The following preliminary comments are offered following our review of the dames and Moore proposed Work Plan for the remedial Investigation/Feasibility Study for the SCP Carlstadt Site. Additional comments may be available by September 19, 1985.

TO: ROBERT SOBOLESKI, Site Manager, BSM
THROUGH: MARJA VAN OUWERKERK, Acting Ass't. Chief, BEERA *mvo*
FROM: DR. THOMAS F. MCNEVIN, Technical Coordinator, BEERA *TFM*
SUBJECT: REVIEW OF SCP CARLSTADT RI/FS DRAFT WORK PLAN

To: Eric Evenson, Superfund Coordinator
From: *RAG* Robert A. Gallagher through Stephen W. Johnson, Supervisor,
Bureau of Ground Water Pollution Analysis, NJGS
Subject: Scientific Chemical Processing Facility, Carlstadt, Bergen
County - Review of proposed work plan

Appendix C Drilling Procedures/Monitor Well Construction Procedures

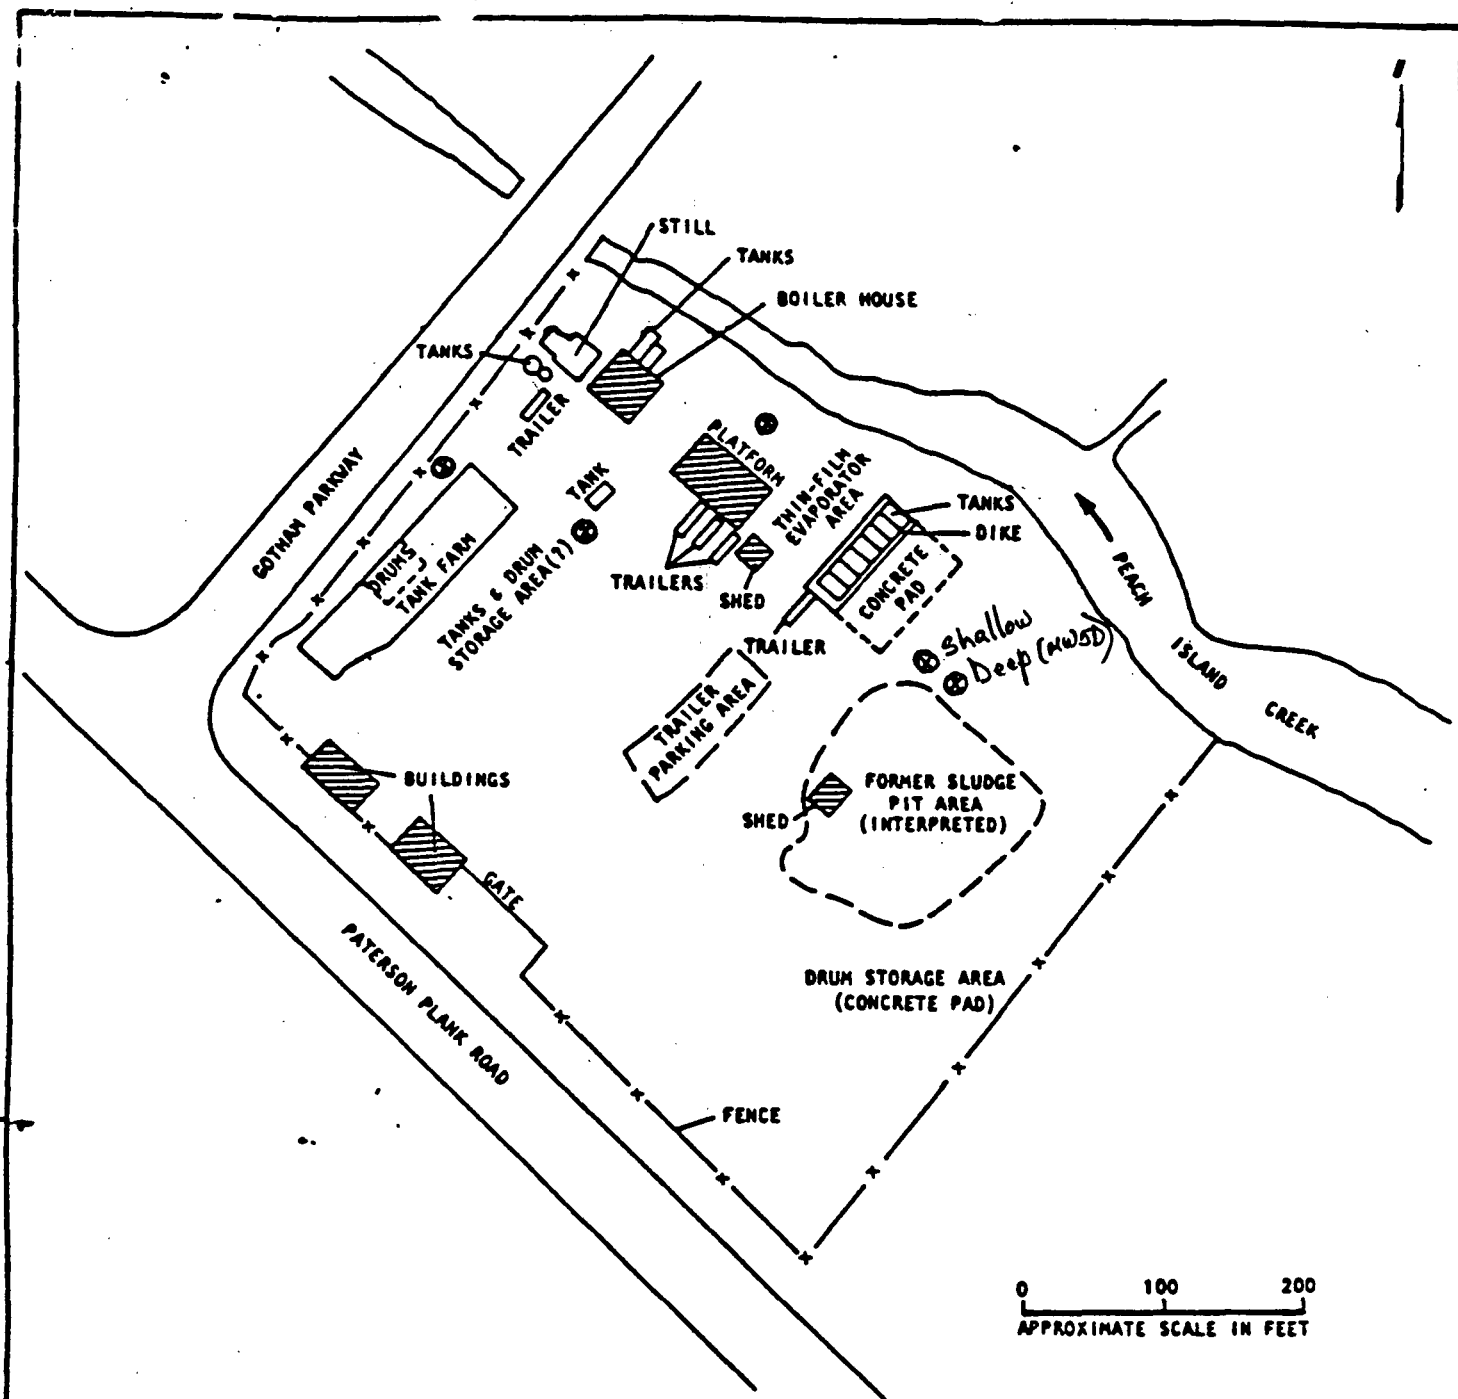
- a. All casing (and well screen) should be composed of schedule 40 stainless steel. This is not specified in the Work Plan.
- b. The well construction procedures proposed for deep wells do not meet NJDEP specifications. The wells must be constructed in accordance with the attached monitoring well specifications. Please note that these specifications require a twelve-inch diameter boring for the eight-inch outer casing.
- c. Clarification of the statement regarding the gravel pack (p. C-3) is necessary.

MONITOR WELL SPECIFICATION FOR
 CONFINED UNCONSOLIDATED AQUIFERS *

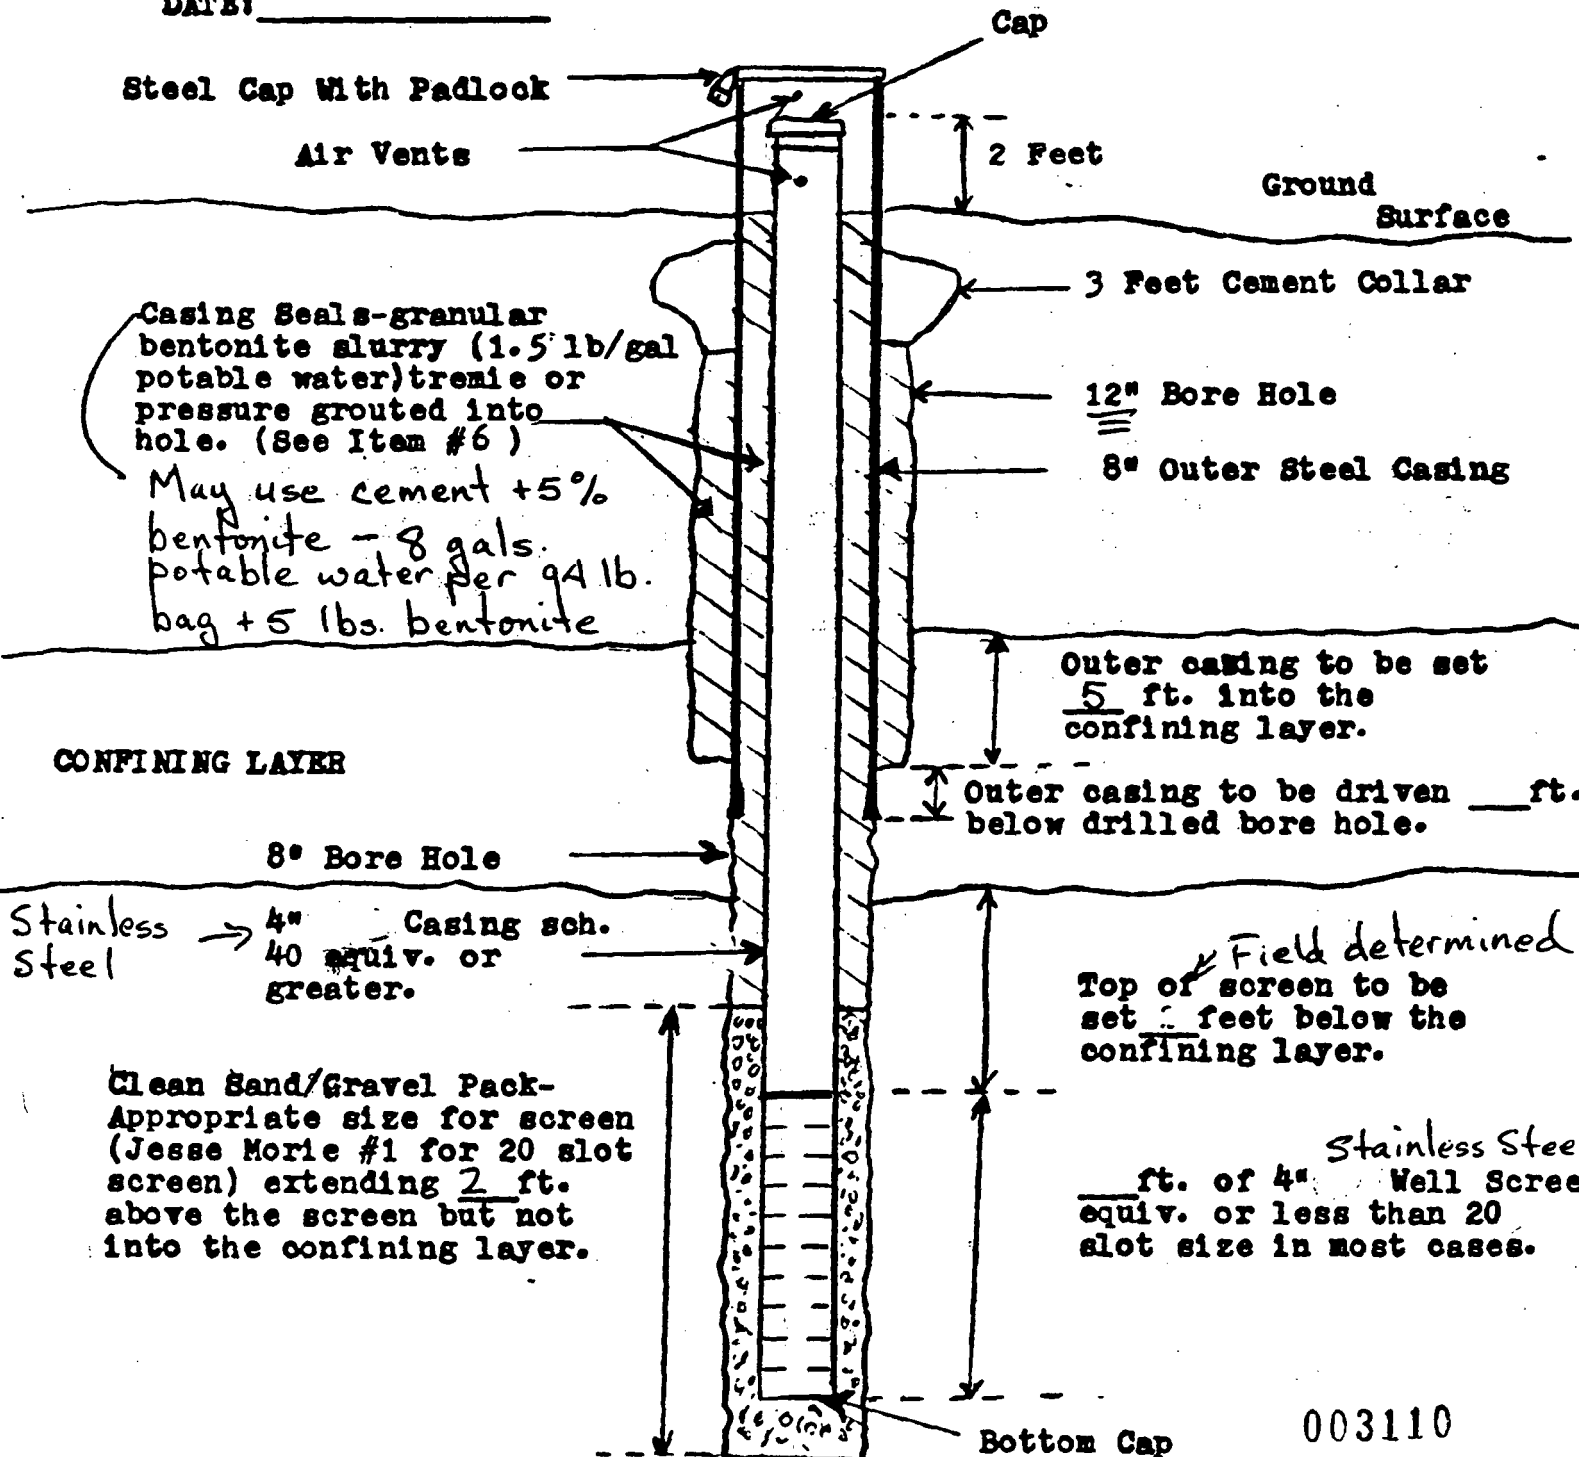
- a. The deep monitoring wells should be screened above the bedrock surface regardless of variations in site stratigraphy. A "clean" well in bedrock does not indicate that ground water in the unconsolidated material immediately overlying it (till) is not contaminated. An investigation to determine ground-water quality in the deep unconsolidated material must be performed.
- b. The location of proposed monitor well 5D is unacceptable. This well should be sited approximately seventy-five feet to the northeast, immediately downgradient of the sludge pit, and paired with a shallow monitor well. The recommended location is marked on the attached site map.

5. ~~Approved high grade sodium base, well sealant type, granular bentonite must be used to seal all casings.~~ Casing sealant, drilling fluids and cement must be mixed with potable water.

7. The grout for the inner ~~PVC~~ cased well must extend to the ground surface.
 8. The cement collar should be installed one (1) hour after the inner casing seal has been emplaced and not while the outer casing seal is setting.

11. If ~~organic~~ organic compounds are to be sampled for, only threaded or press joints (no glue joints) are acceptable.
 12. Locking caps must be provided to secure each well.
